## STRUCTURAL ENGINEERING INSPECTION

### General: Purpose - Roof Framing Review

As requested, personnel of GreenWorks Engineering and Consulting have completed a structural review of the address referenced above. The purpose of the observation was to collect information necessary to assess the condition and performance of the new roof framing supporting the new RTUs. Structural drawings from Wright Structural Engineers, project number 230764, dated May 18, 2023 were provided by the client.

## Primary Roof Framing: Primary Photos

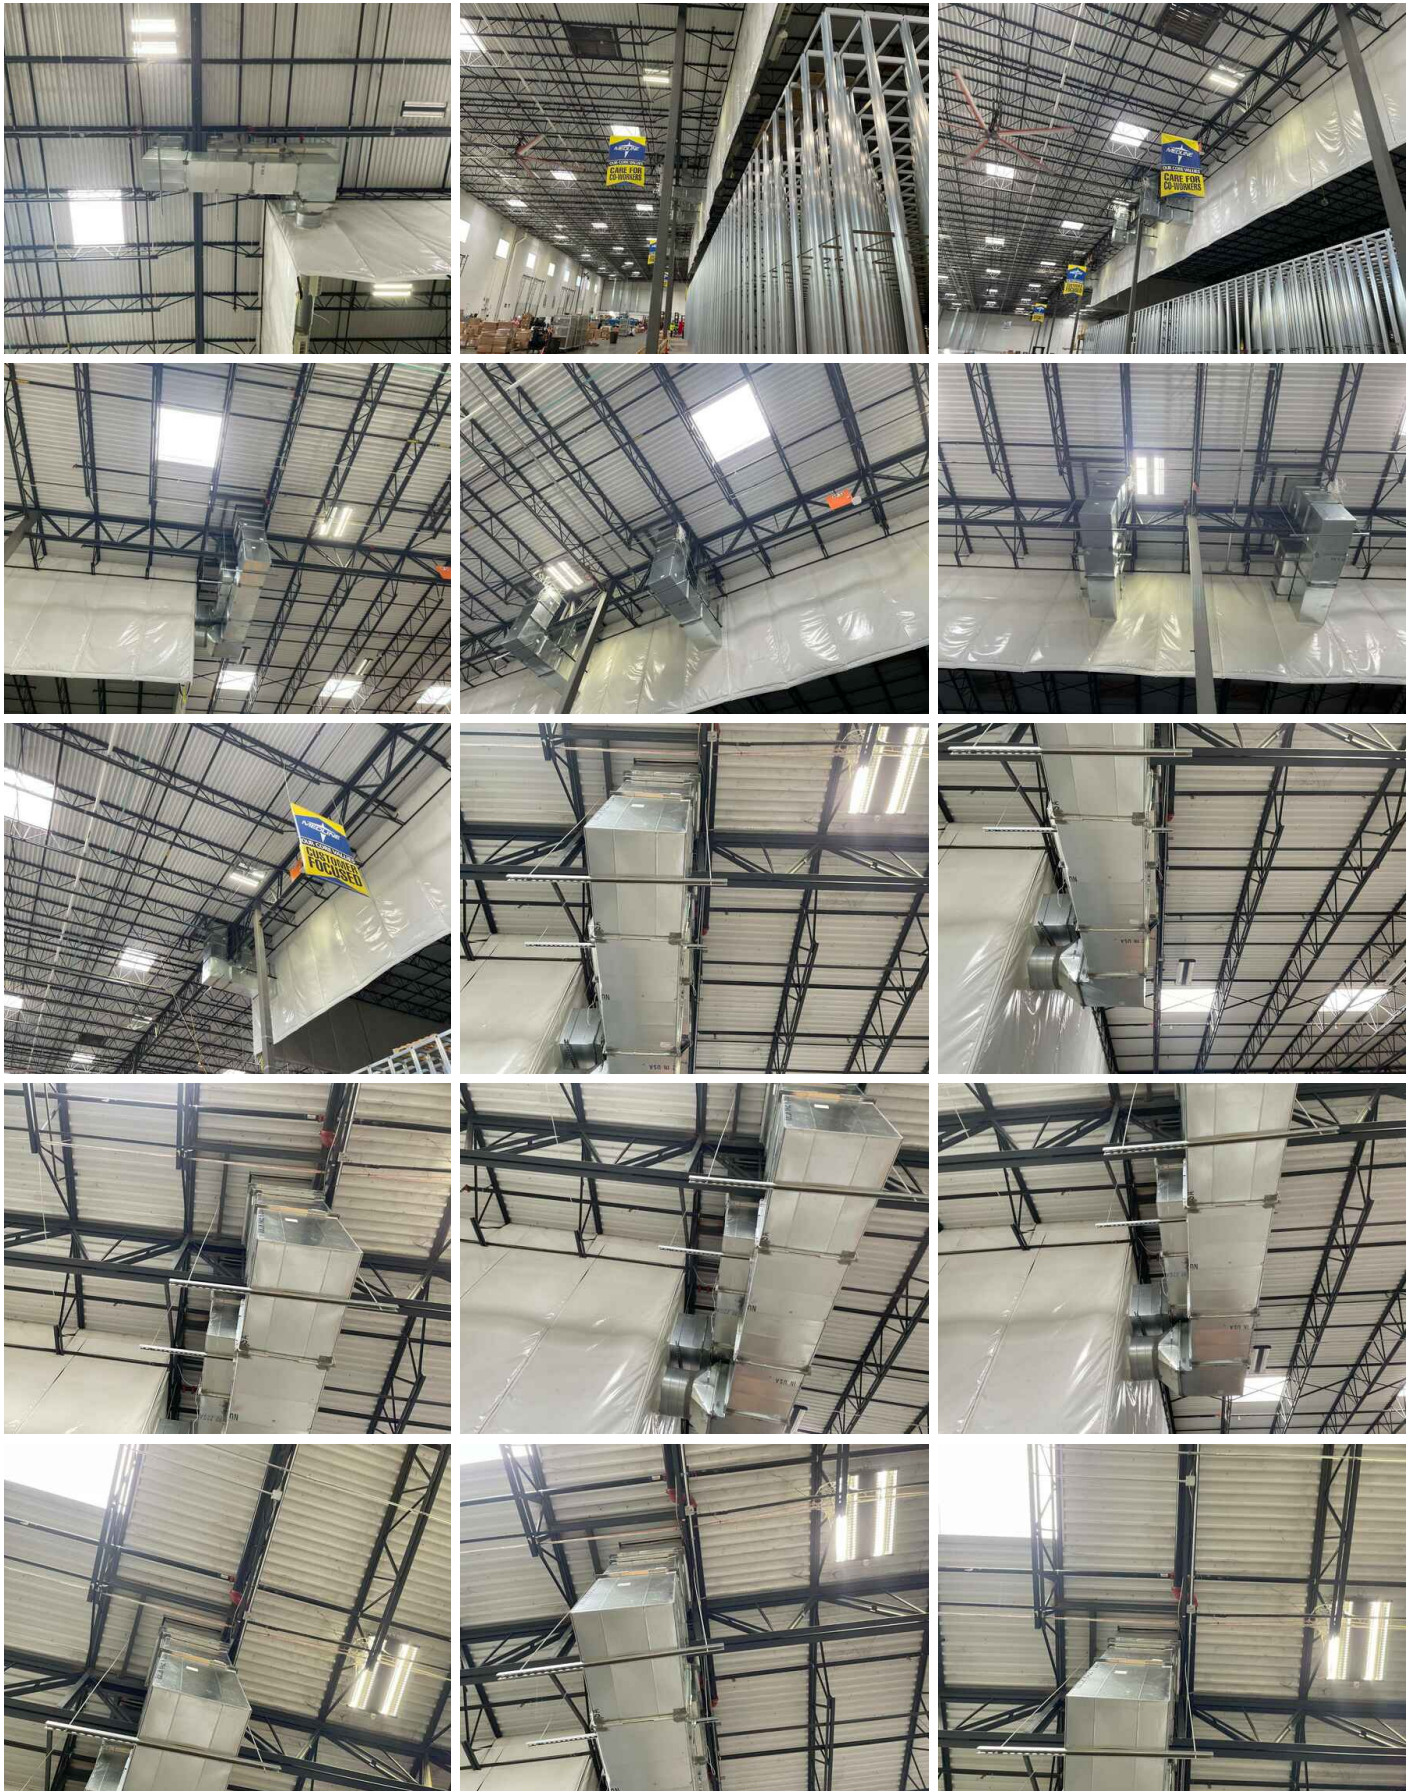
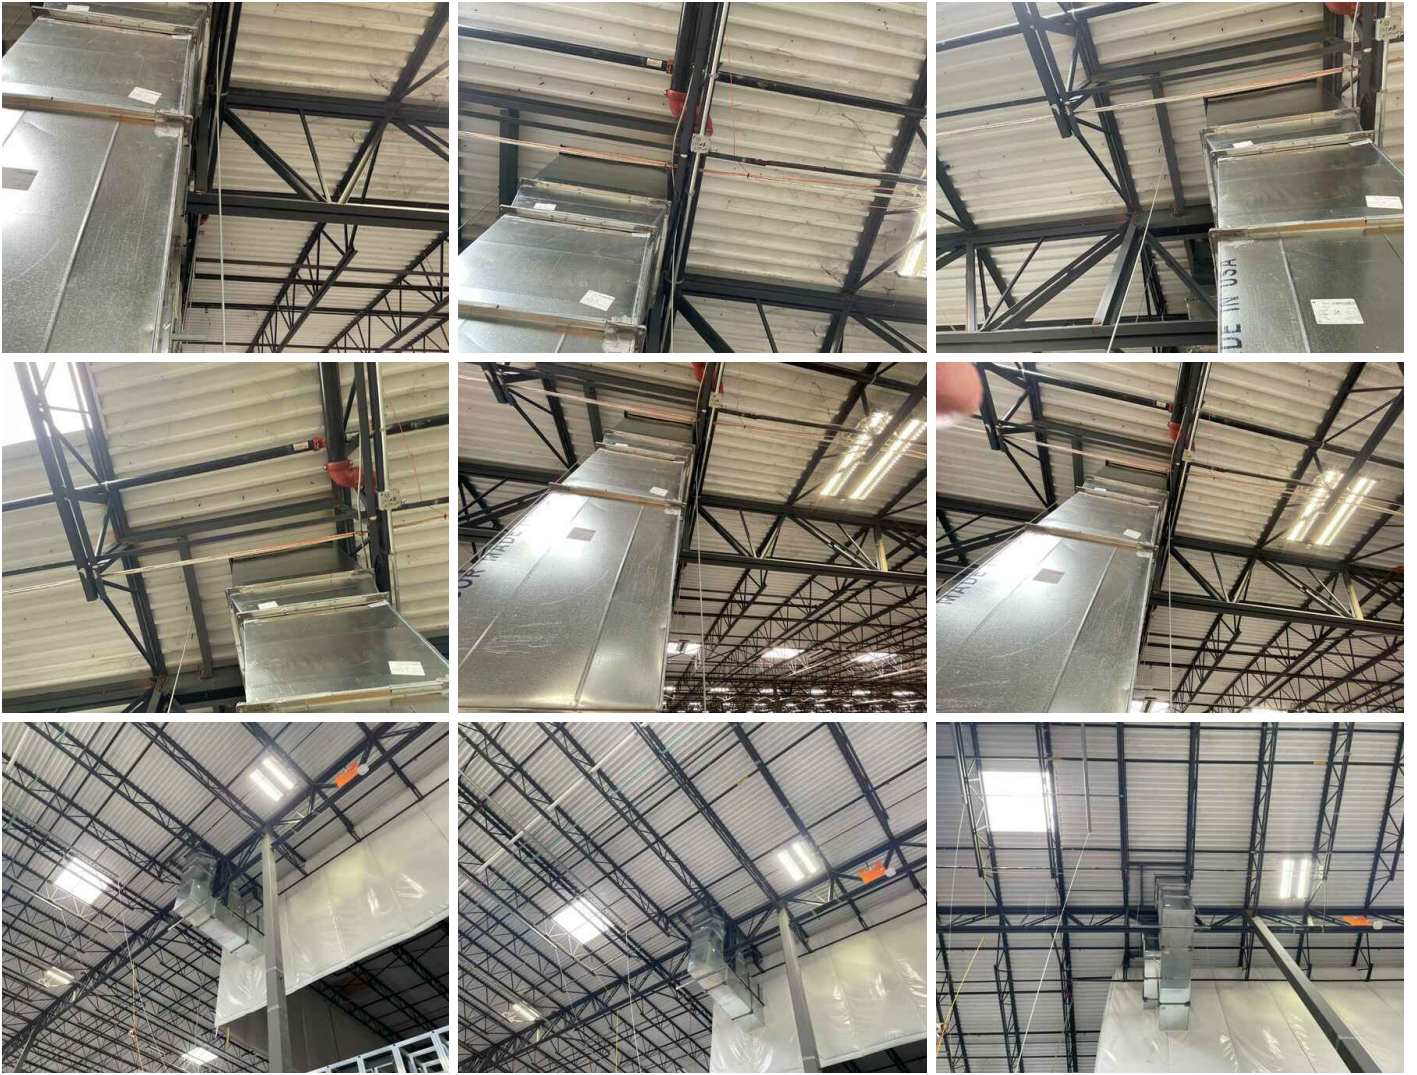
Per the client, four new RTUs were installed along column line J (furthest south bay) of the structure. New RTU framing was supported by C8x11.5 along all supporting edges of the RTU. All C8x11.5 were welded all around to the existing steel joist with additional (2) L2-1/2"x2-x1/2"x3/16 angles added to the steel joists web vertically.

Based on our observations, the subject framing appeared to be in good condition and in substantial compliance with the referenced documents. No apparent structural distress was observed. It is our opinion that the subject framing is adequate to support the current loads and does not require structural mitigation.
